Carlisle | Wortman

RE: Planning Commission Agenda Packet for September 15, 2021, Regular Meeting

- a. **SLU 21-01 Railsplitter #2 – Special Land Use - Multiple Properties.** An application has been received for a special land use for large-scale solar project north of Arkona, south of Talladay, east of Sanford and west of Gooding encompassing thirteen (13) parcels and 478 acres of land. A pre-application conference was conducted at the April 2021 Planning Commission meeting. A public hearing has been published/notified and will be conducted at this meeting.

- b. **SP21-03, Railsplitter #2 – Preliminary Site Plan - Multiple Properties.** In addition to special land use approval, the applicant is seeking simultaneous review of the preliminary site plan for the Railsplitter #2 project. Approval of the preliminary site plan is conditioned upon receiving special land use approval and is being conducted at the applicant's risk.

D-300

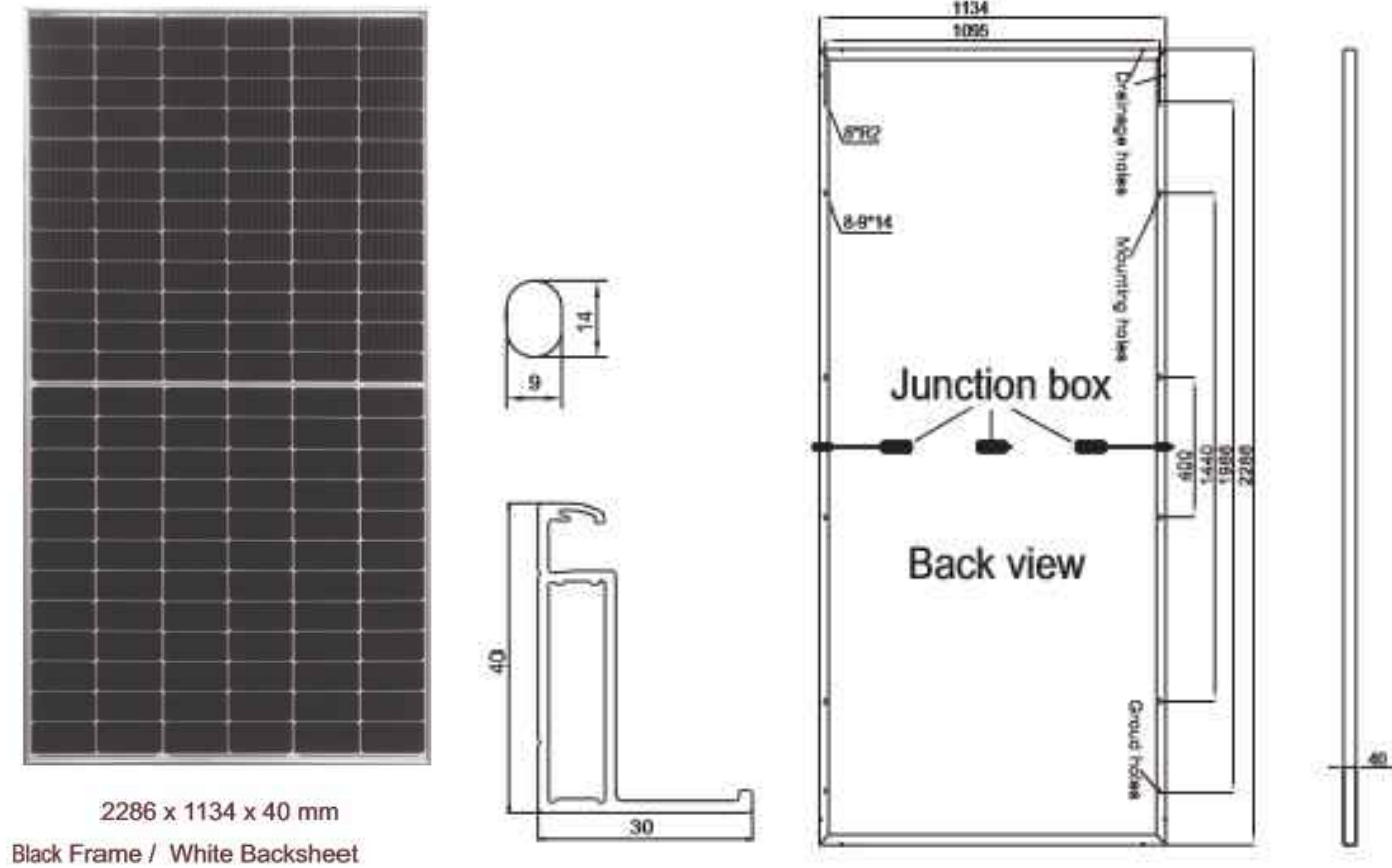
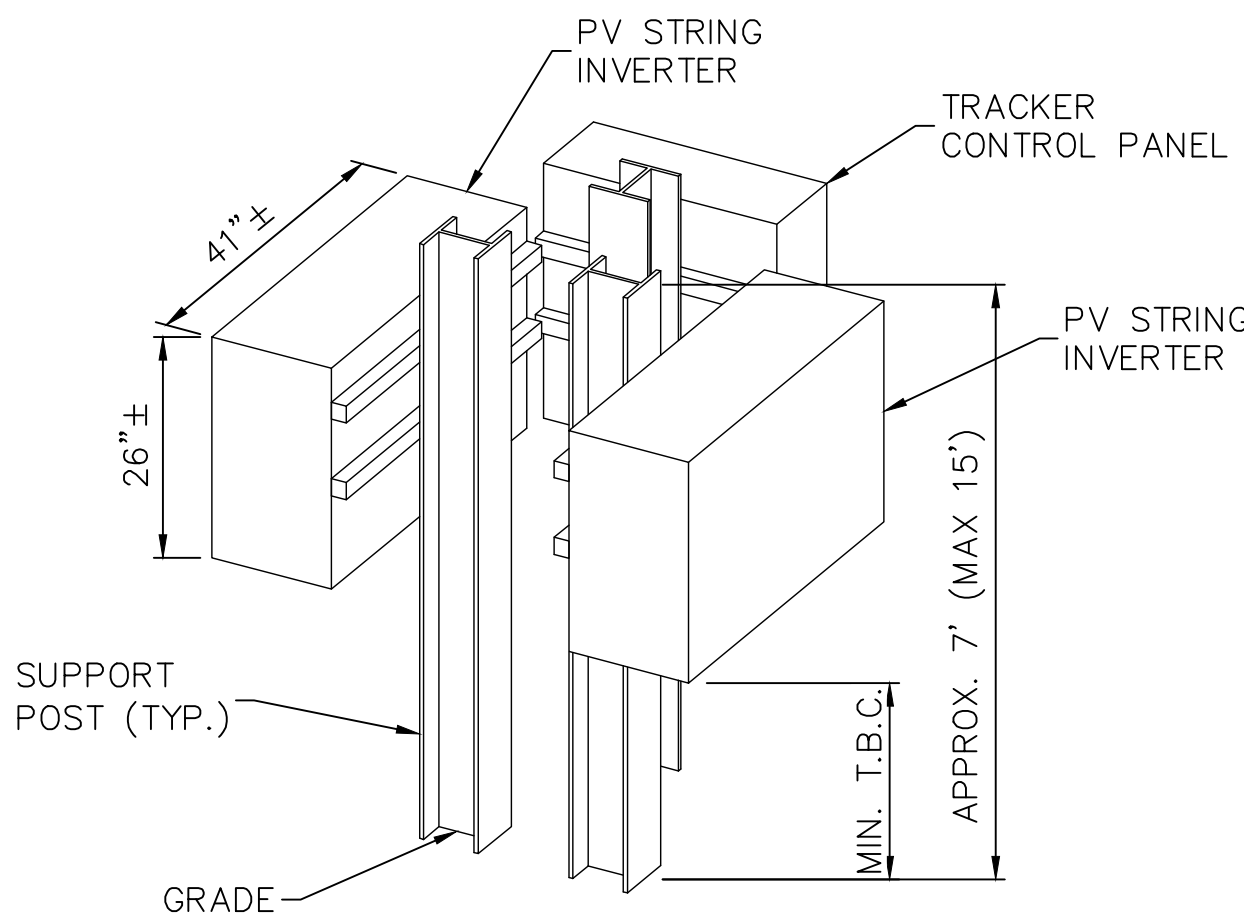
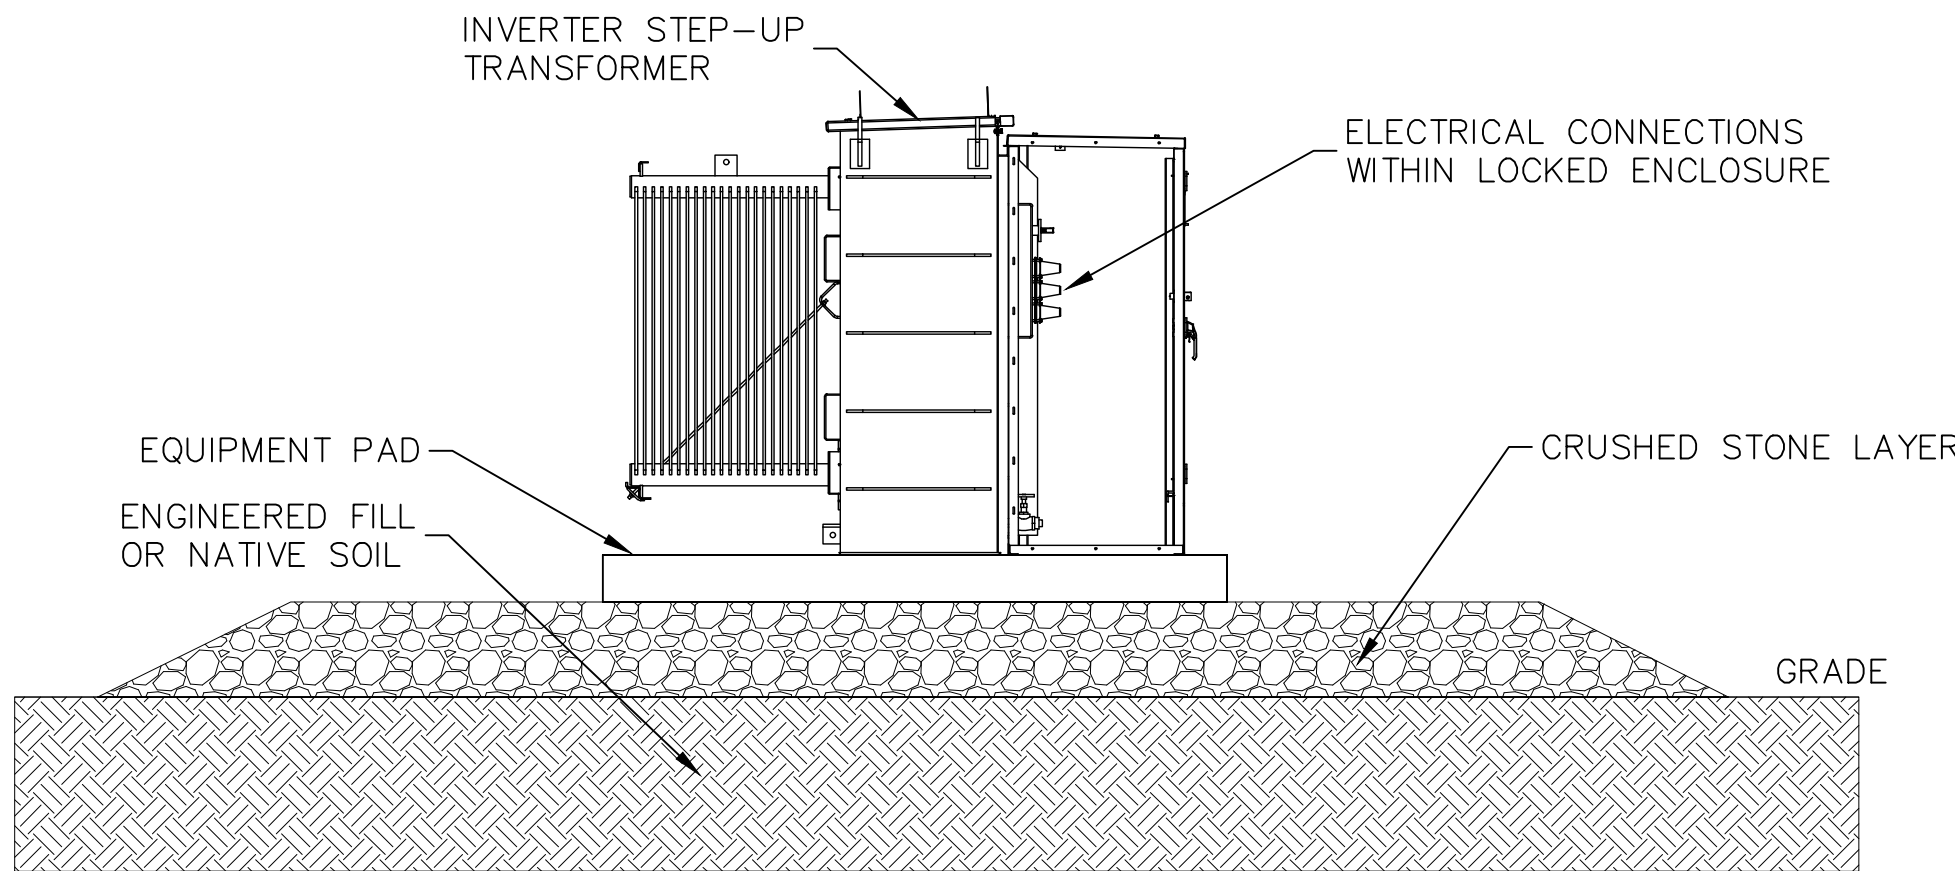
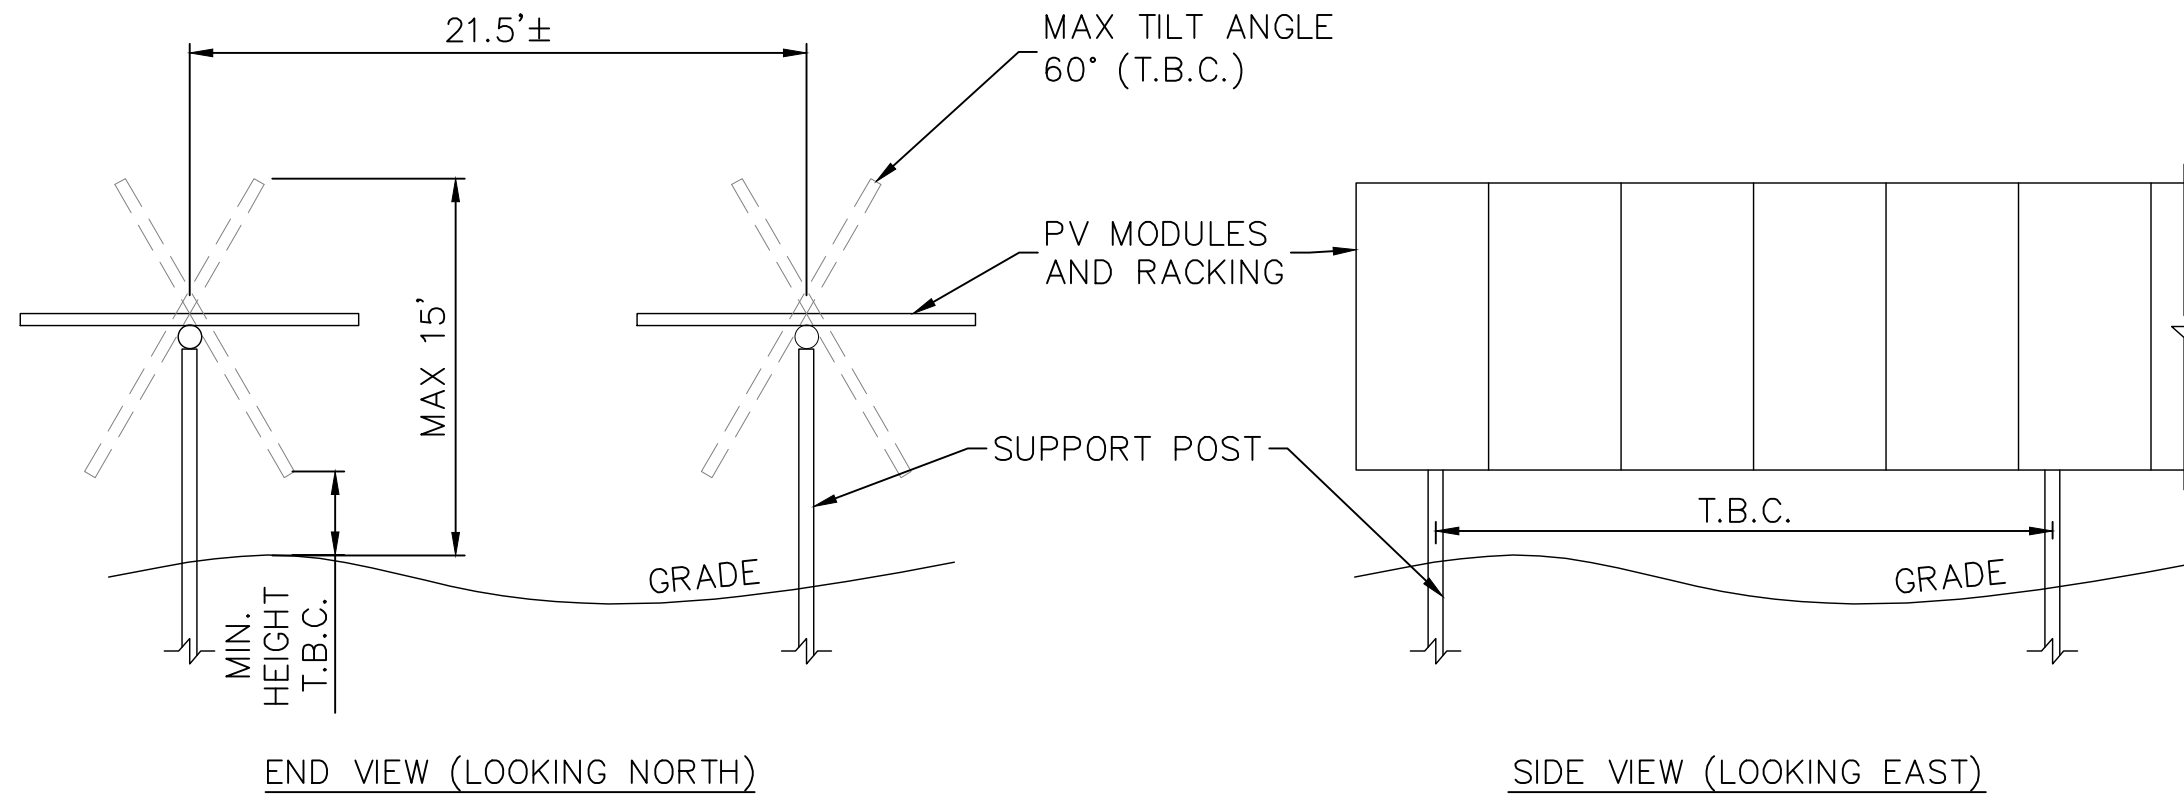
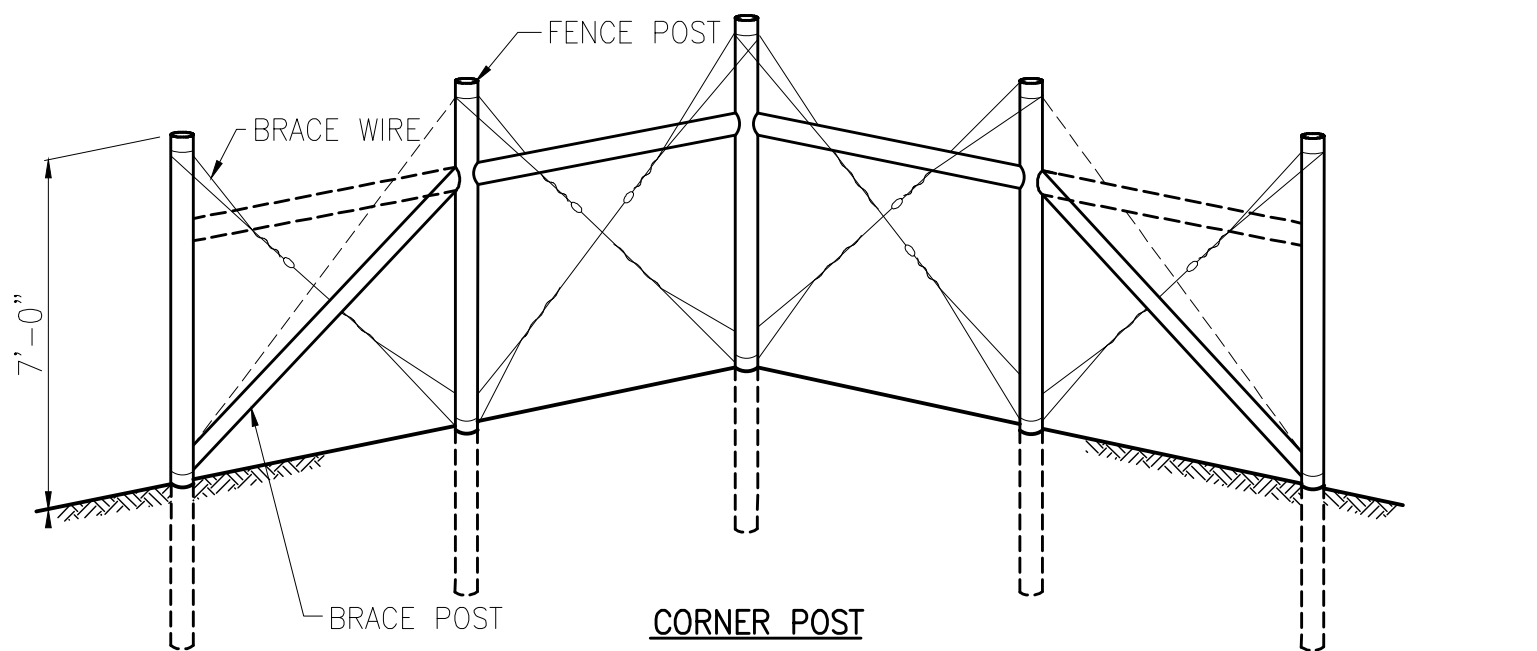
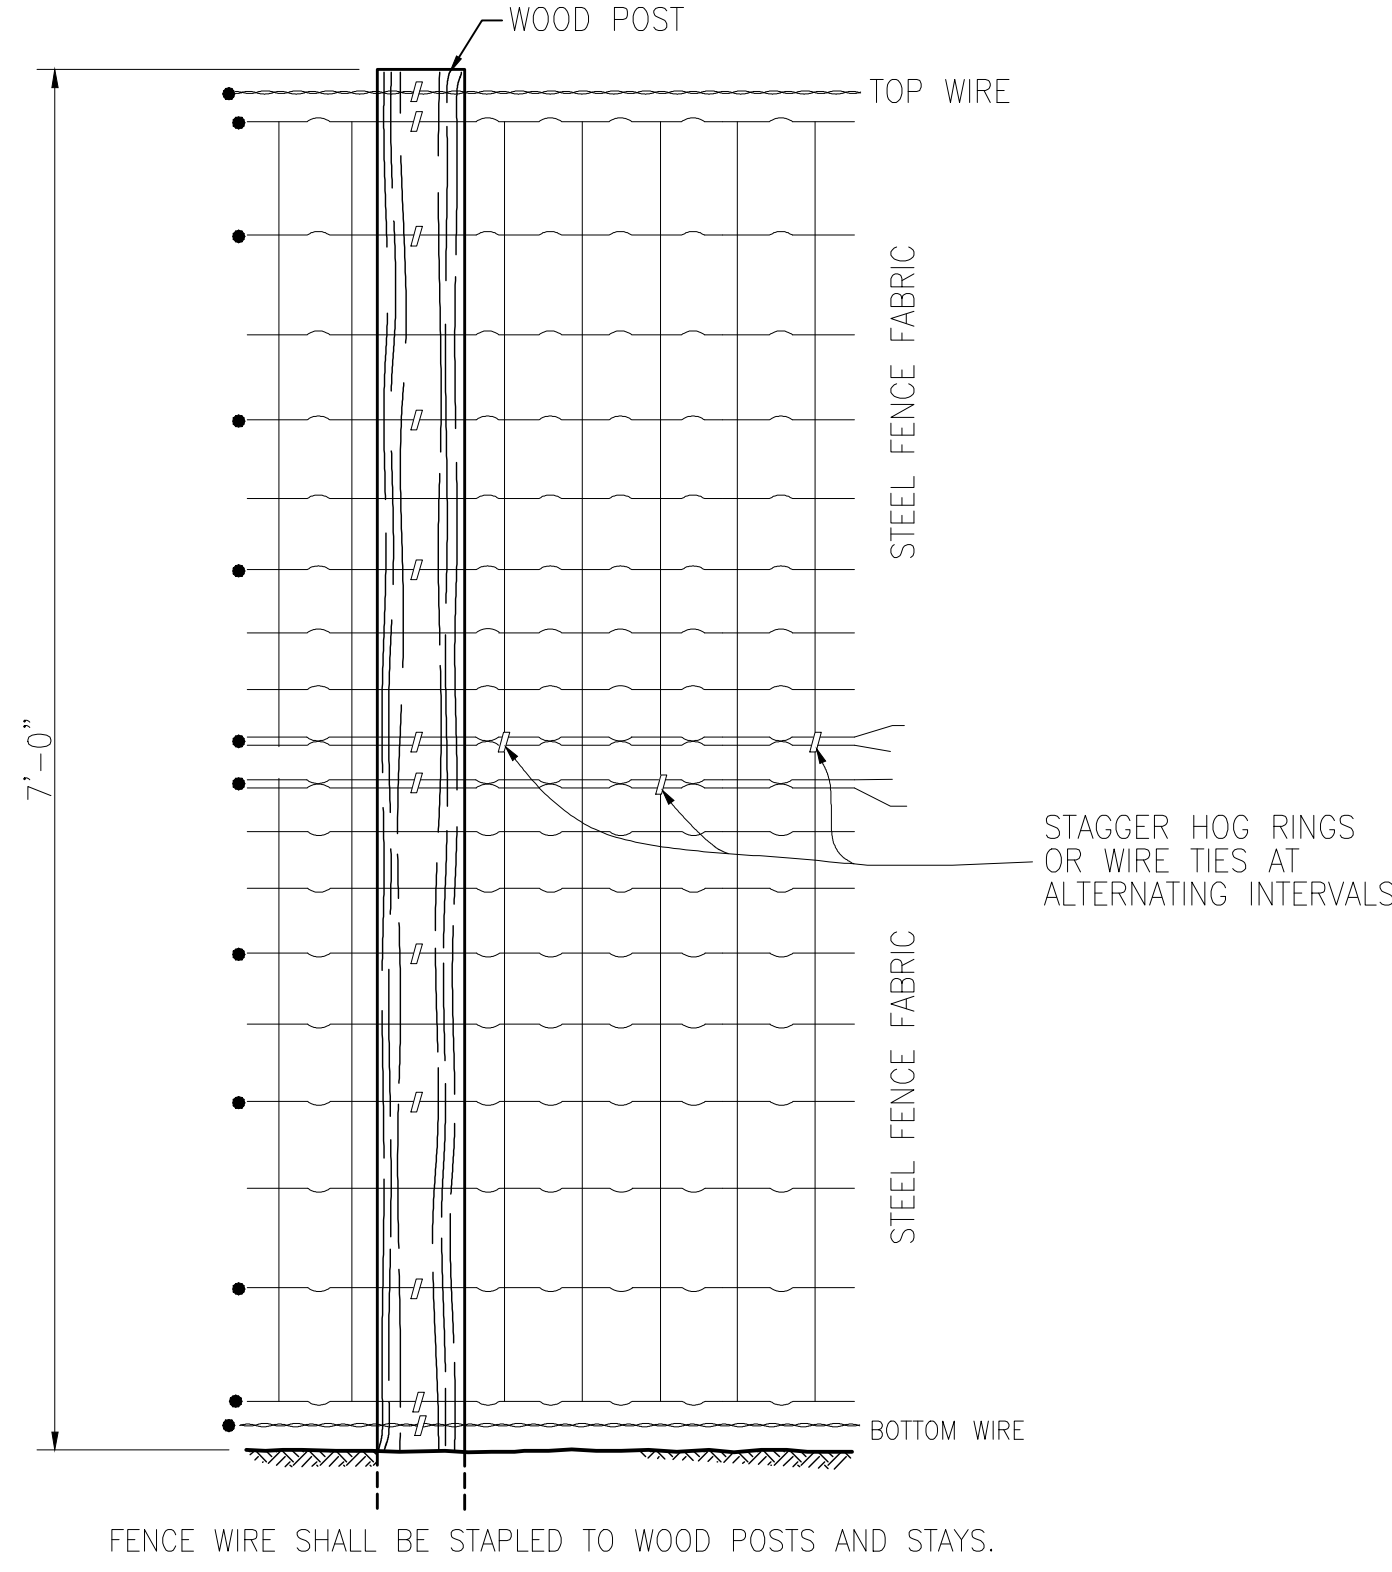
CWA Comment: The location of all proposed arrays, structures, transmission lines, etc. have been provided on the preliminary site plan. The height of proposed site elements is proposed on various on the last page of the site plan (Sheet D-300 - Appendix D) and include maximum height of arrays – 15 feet; fence height – 7 feet; and maximum height of inverter station – 15 feet.
